# **Mobile Intel<sup>®</sup> Celeron<sup>®</sup> Processor at 466 MHz, 433 MHz, 400 MHz, 366 MHz, 333 MHz, 300 MHz, and 266 MHz Specification Update**

Release Date: December 2002

Order Number: 244444-039

**Figure 1. An Example of Microcontroller Driven Thermal Management**

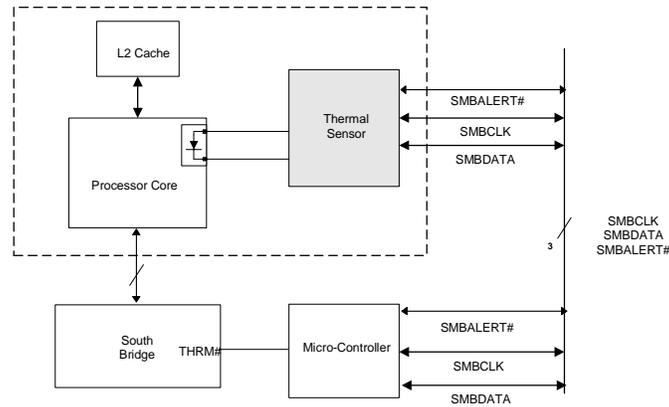
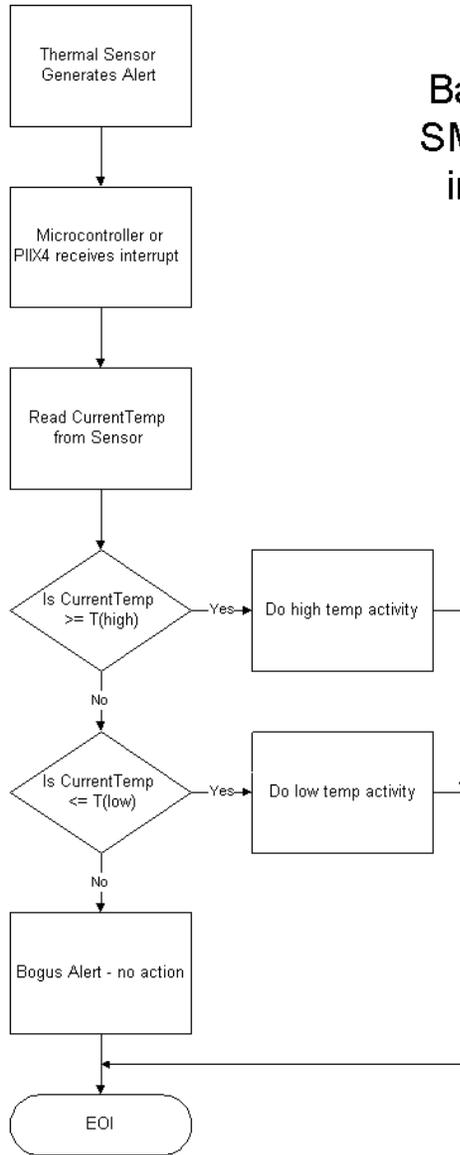
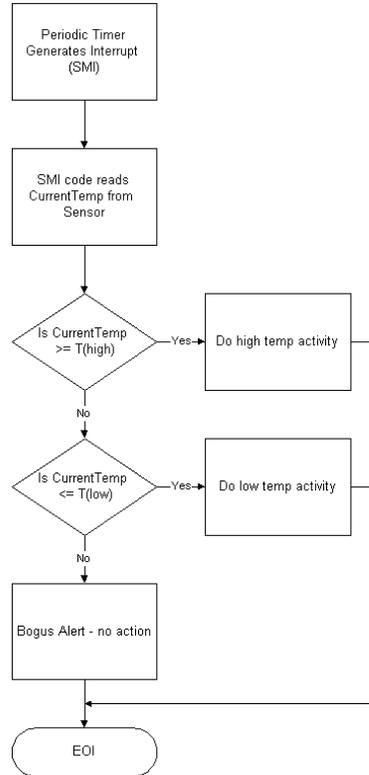
## ***H29. Thermal Sensor May Assert SMBALERT# Incorrectly***

**Problem:** The Intel Celeron Processor Mobile Module has a thermal sensor that monitors the processor core's temperature. Please note that desktop systems could have a similar thermal device. The thermal sensor asserts SMBALERT# if the processor temperature exceeds the temperature limits set in the Alarm Threshold Registers ( $T_{HIGH}$ ,  $T_{LOW}$ ). It also sets the corresponding Status Register bits to identify the cause of the interrupt. Figure 1 gives one example of the how the SMBALERT# signal could be used in a system.

**Implication:** There is no system impact from this erratum if temperature polling is used for processor thermal management. If the SMABLER# interrupt is employed to manage processor thermal sensing, then servicing the false interrupt may result in premature system action depending on the software and hardware implementations used. The rate of the false interrupts is less than the auto-convert rate of the thermal sensor.

1. Before servicing an interrupt from the thermal sensor, read and compare the processor thermal reading with the threshold limits ( $T_{HIGH}$  or  $T_{LOW}$ ). Figures 2 and 3 provide basic flowcharts for the implementation of this workaround in an interrupt driven system.
2. If the firmware implemented polls the Status Register only, then before taking any action, re-read the temperature register and do a comparison with the alarm threshold limits ( $T_{HIGH}$  or  $T_{LOW}$ ) to determine if the value is actually still within the temperature window.
3. Use a temperature polling scheme to monitor the processor temperature.

Figure 2. Workaround Flowchart: SMBALERT#-Driven System

**Figure 3. Workaround Flowchart: SMI#-Driven System**
